Key Adjustments to the South Central Waterfront Combining District and Density Bonus Program

May 20, 2024

Section 3.3.2

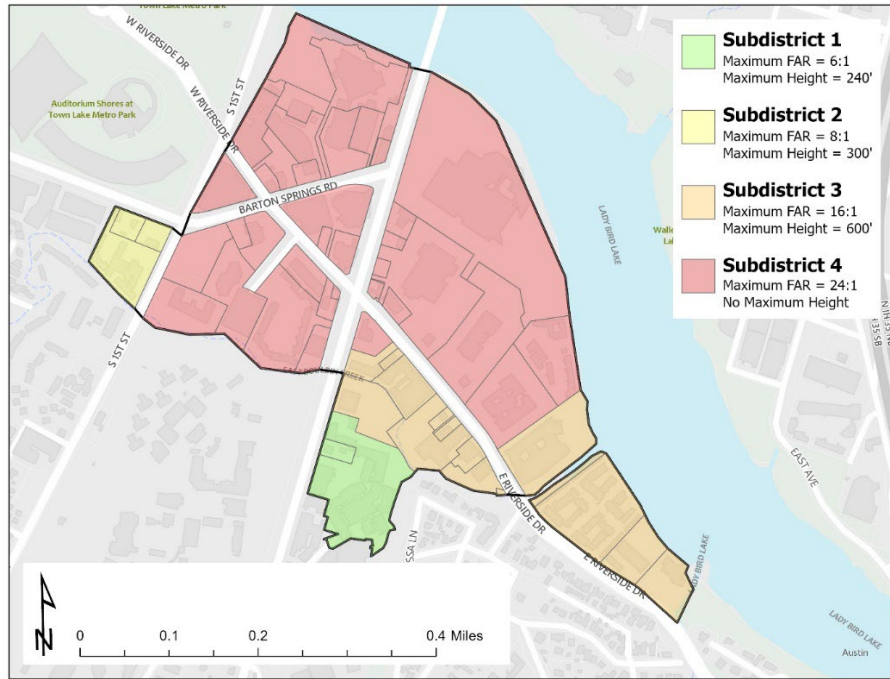
Removed Subdistrict 1 (3:1 FAR and 120' max height). Subdistrict map changed per the request of the Planning Commission to match the map below:
